TRANSMITTAL COVER SHEET

DATE: 21 June, 2024
TO: ALL PLAN HOLDERS OF RECORD
FROM: HUNTER SWATEK, AIA, PROJECT MANAGER
PROJECT: RAINBOW CITY RECREATION CENTER
GMC PROJECT NO. ABHM230021
RE: ADDENDUM NO. 3 AND
ACKNOWLEDGEMENT OF RECEIPT OF ADDENDUM NO. 3

ADDENDUM NUMBER 03

**PROJECT: RAINBOW CITY RECREATION CENTER
GM&C PROJECT NO. ABHM230021**

C-602

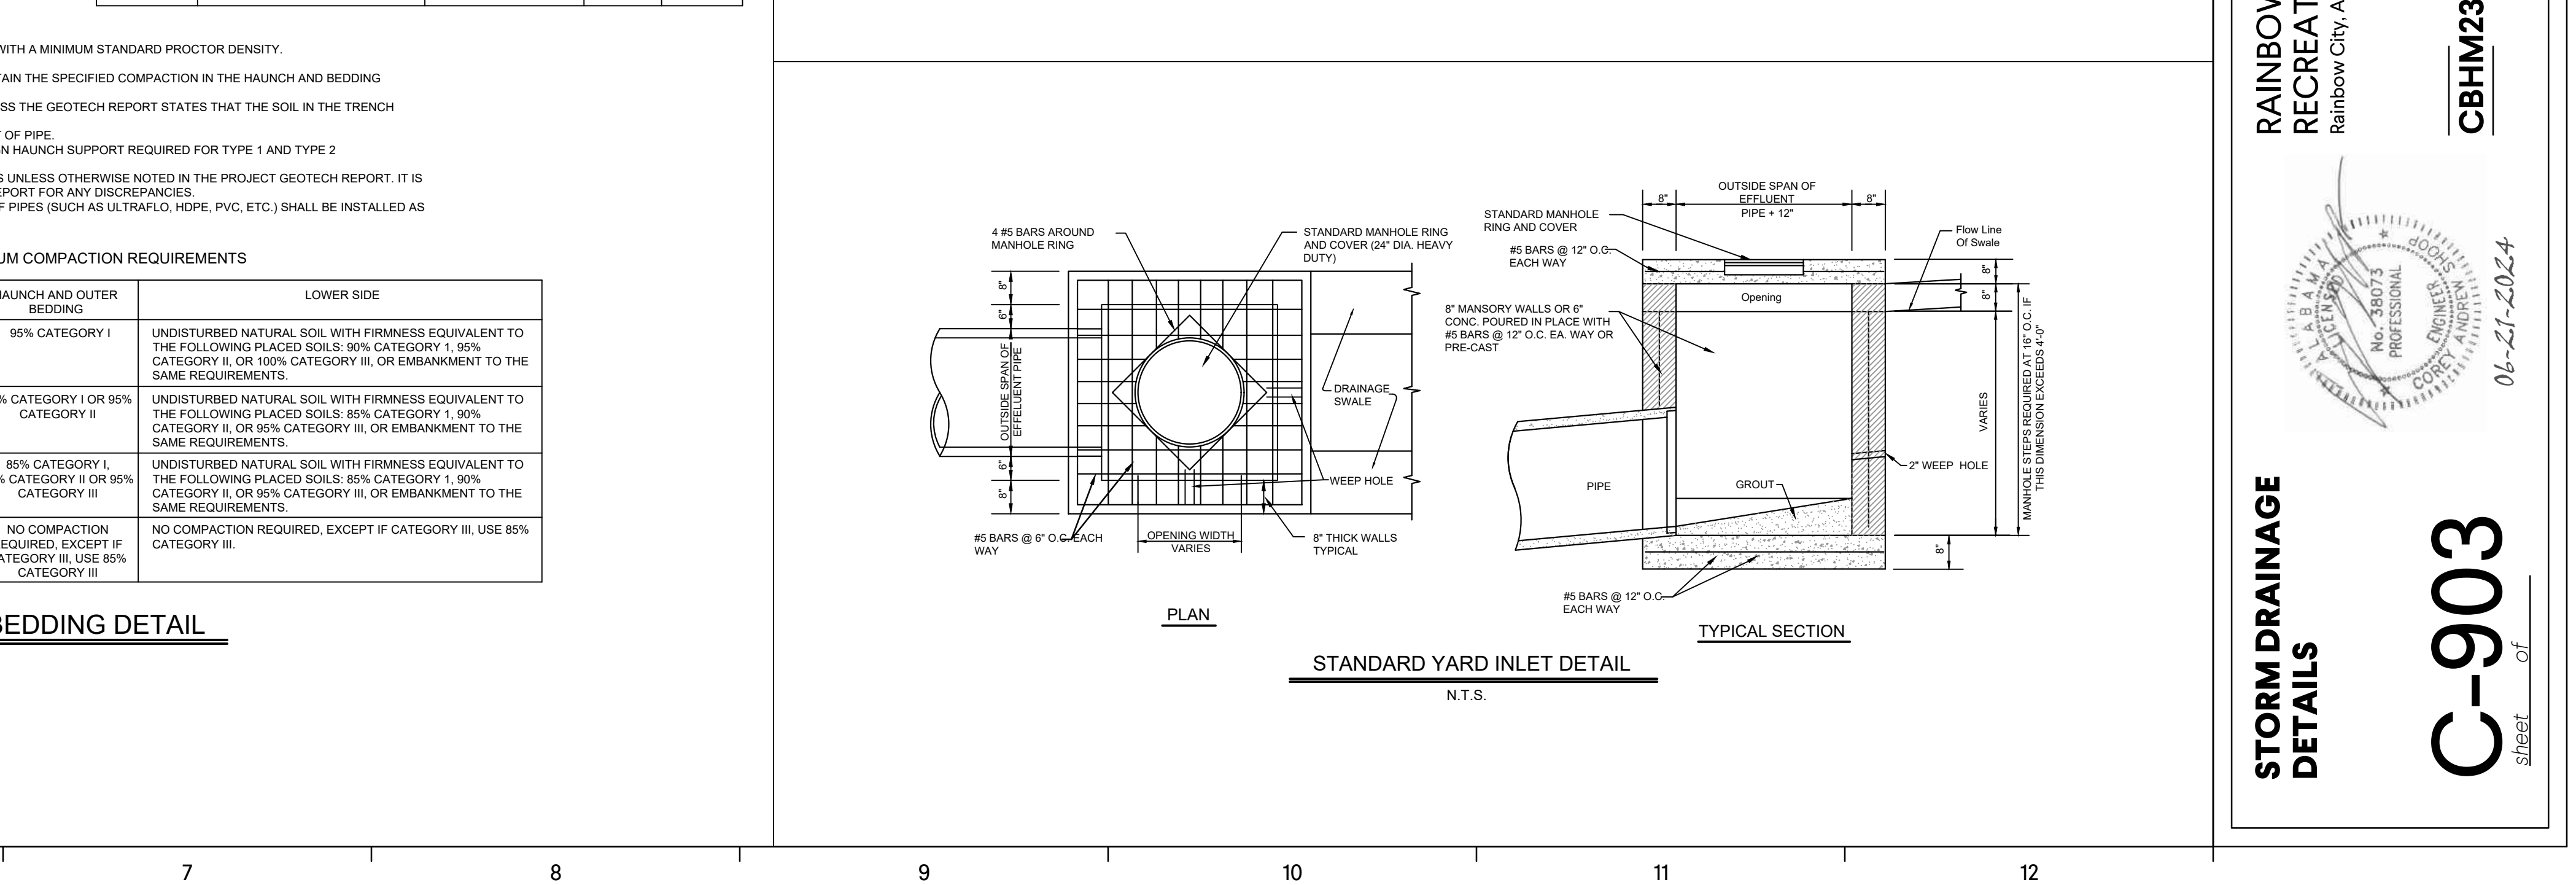
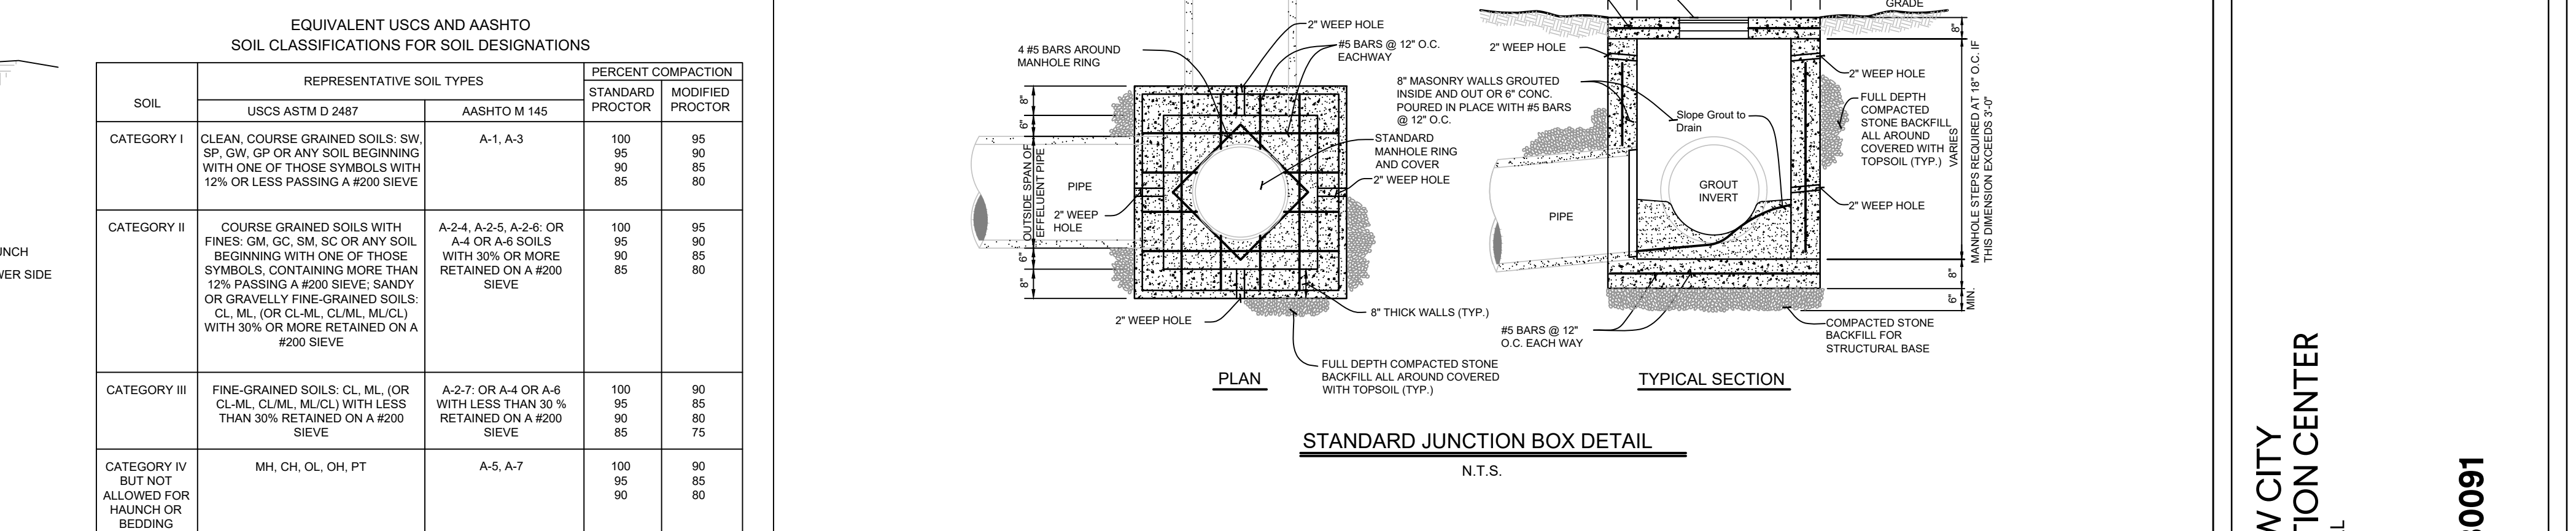
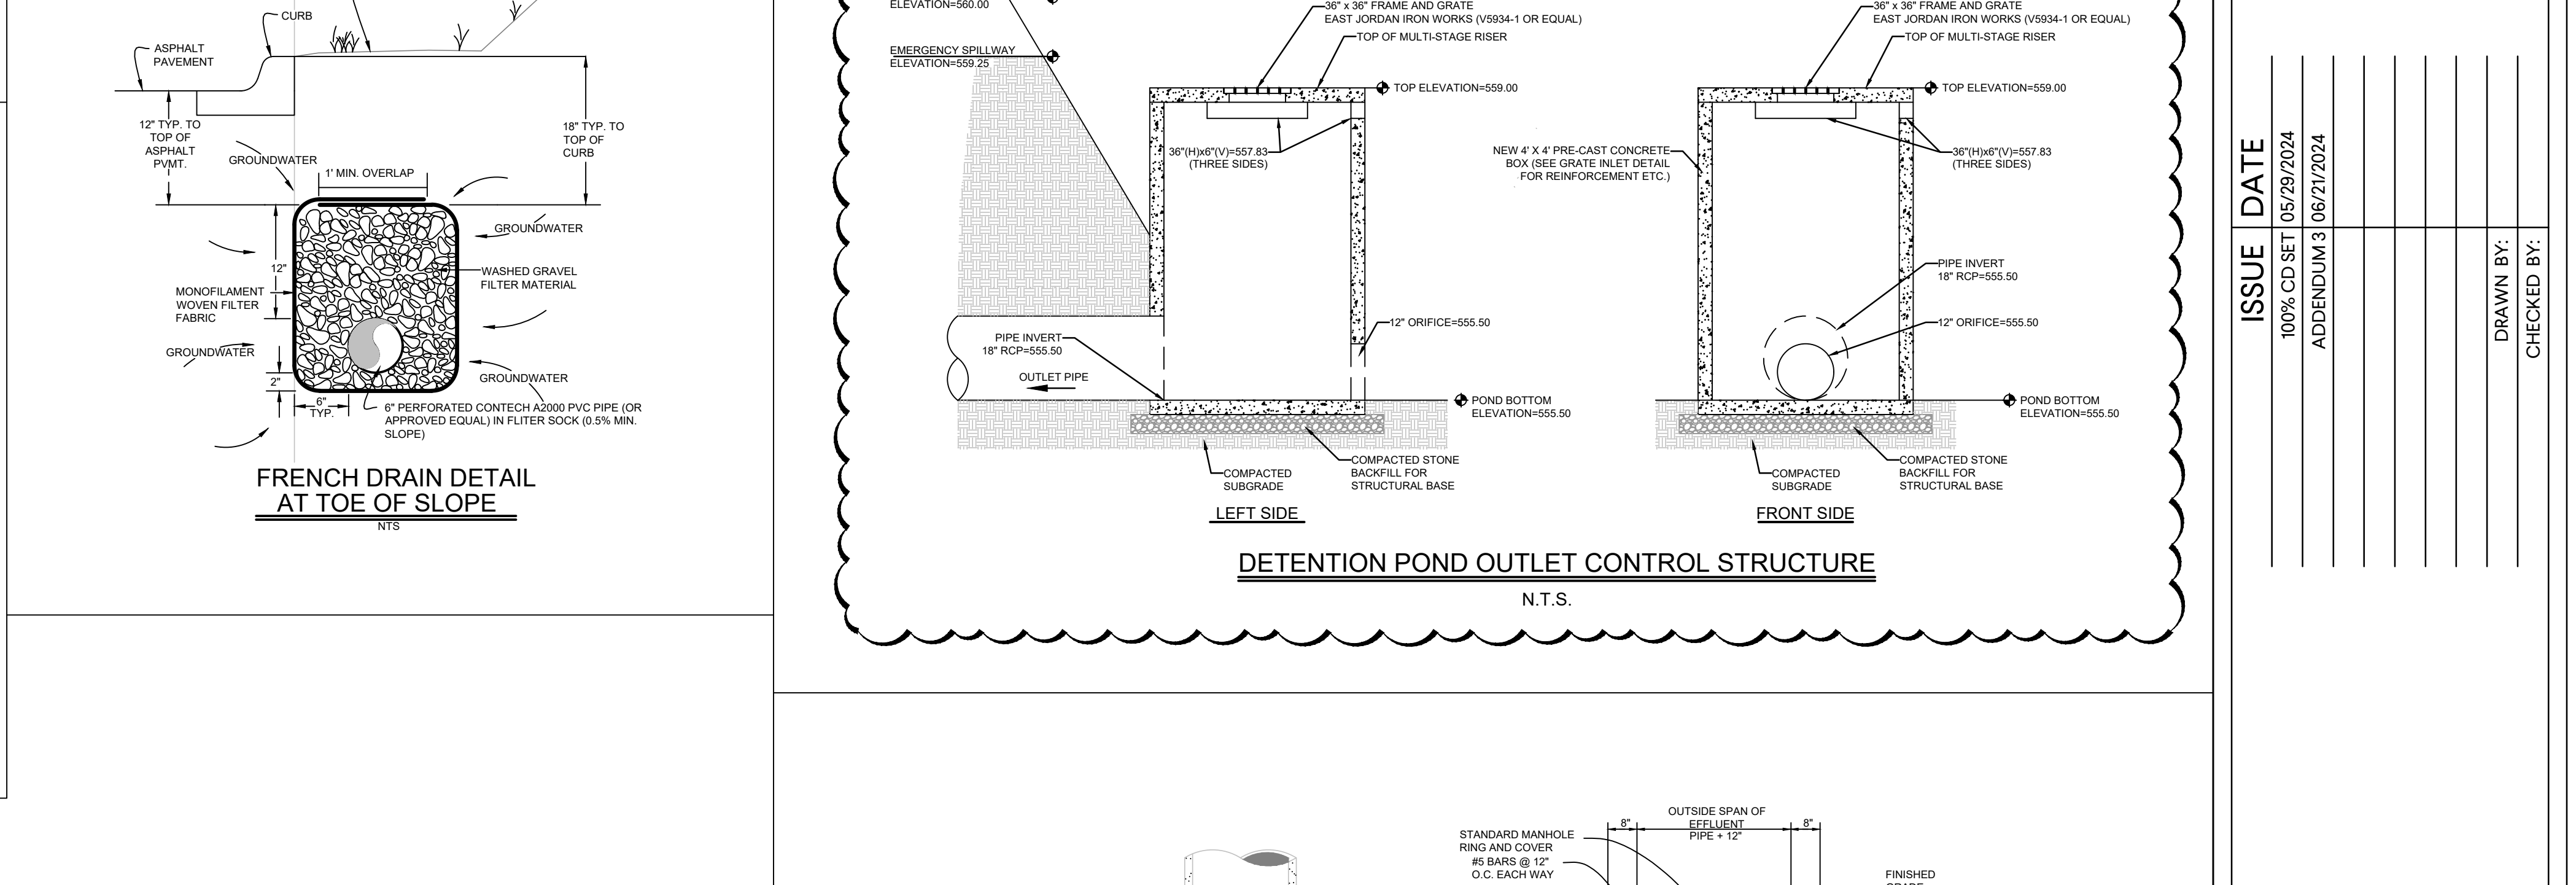
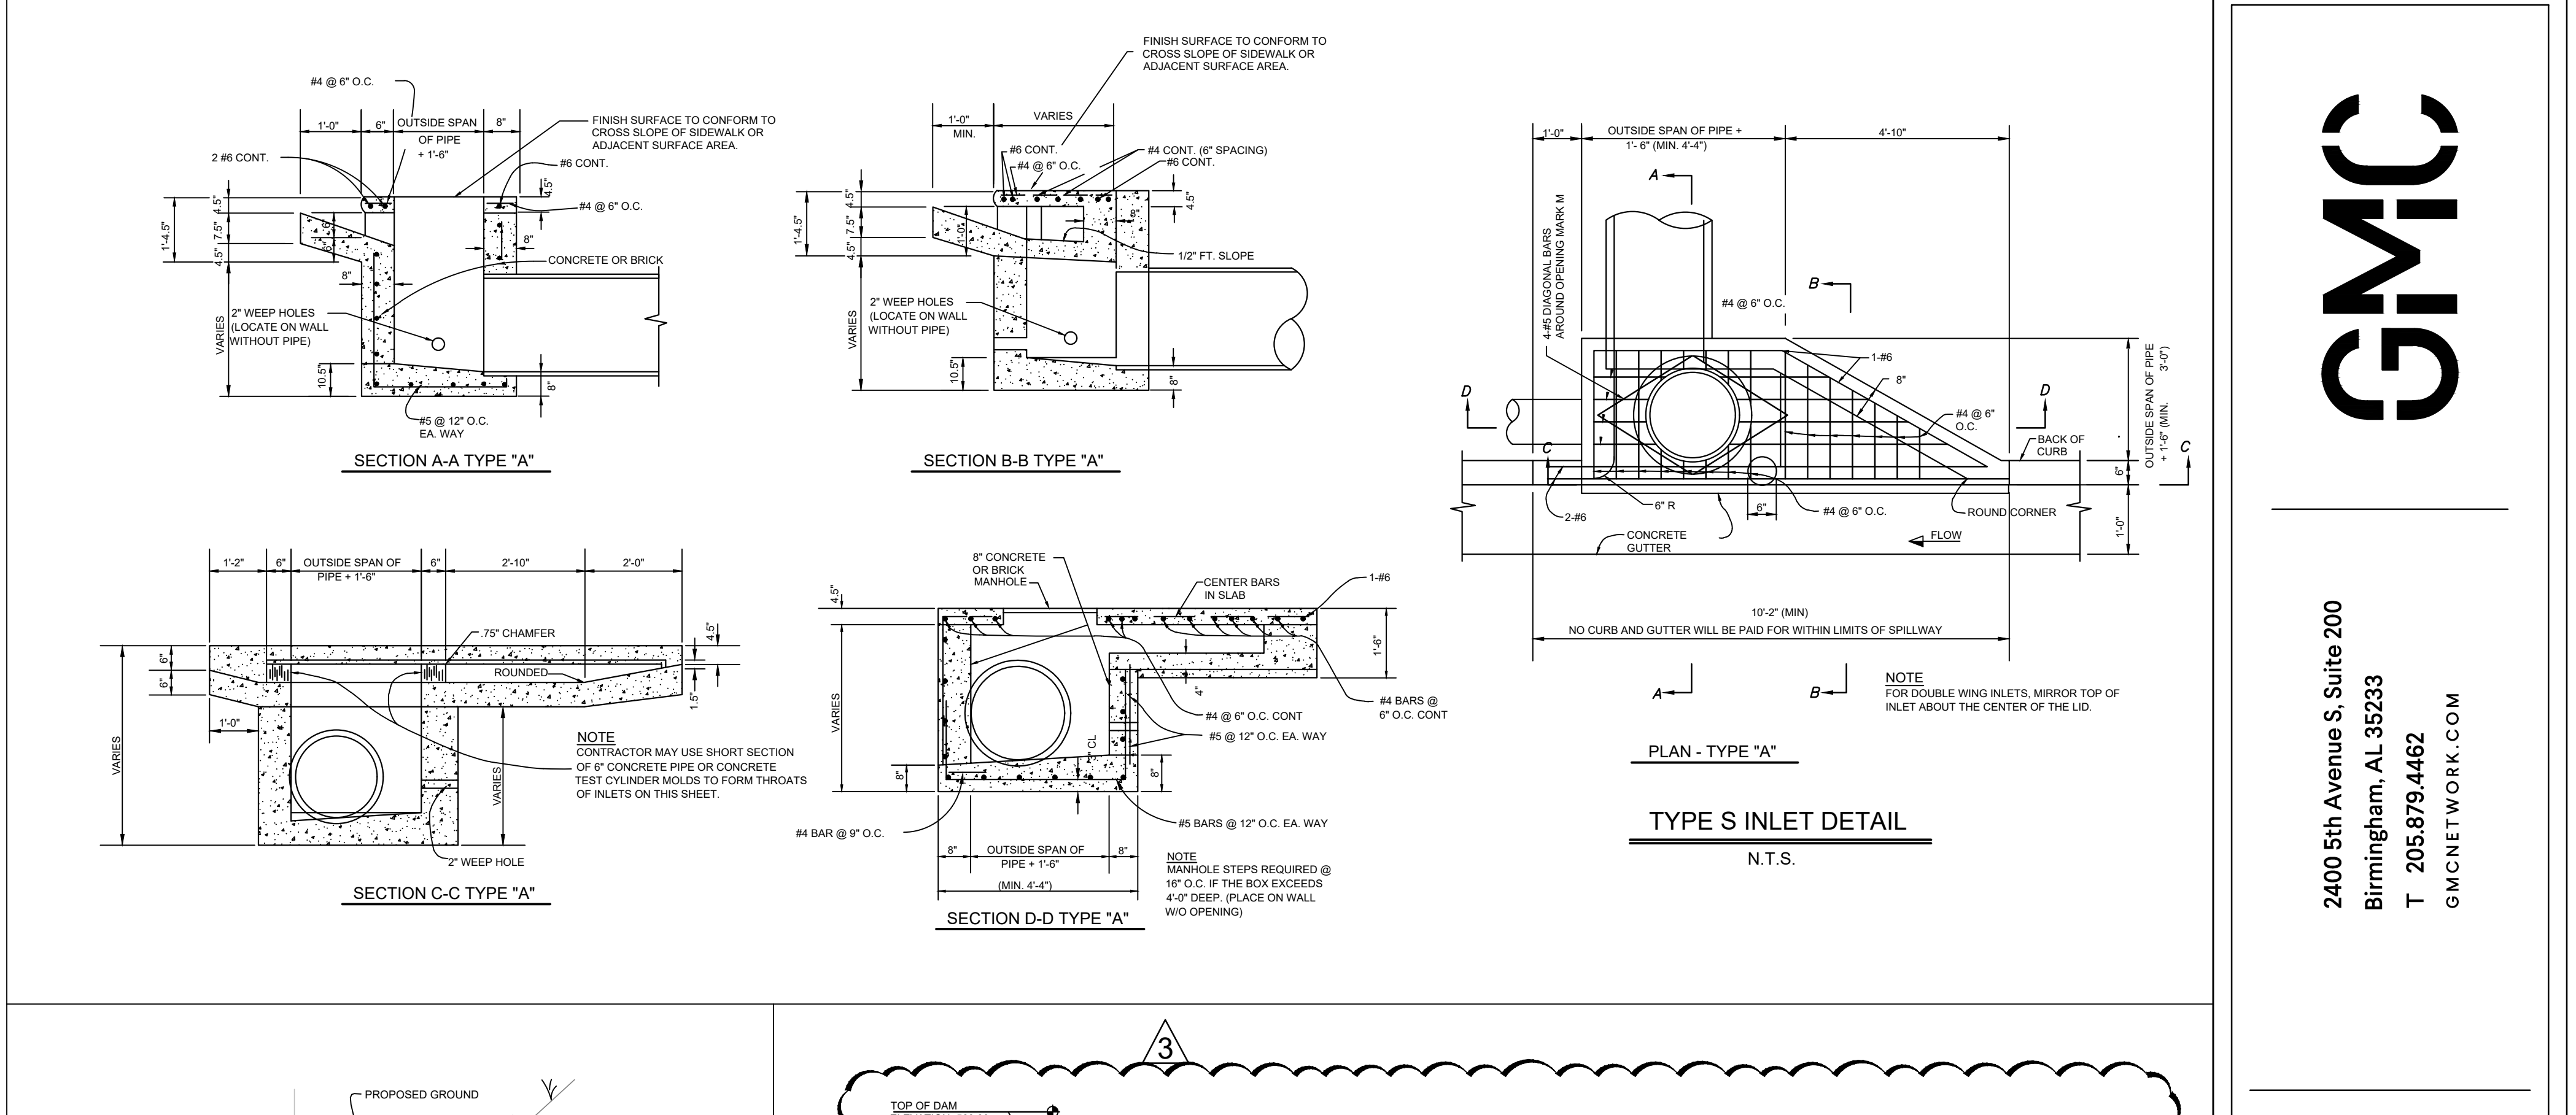
- a. REVISED Construction exit pad
 - b. REVISED Outlet protection
 - c. REVISED silt fence extents
 - d. REVISED Erosion control extents
- M. **C-602** – Alternate Erosion and Sediment Control plan

- a. REVISED Notes and measures
- N. **C-903** – Storm Drainage Details
 - a. REVISED Outlet Control Detail
 - b. ADDED Detail for outlet protection and concrete encasement
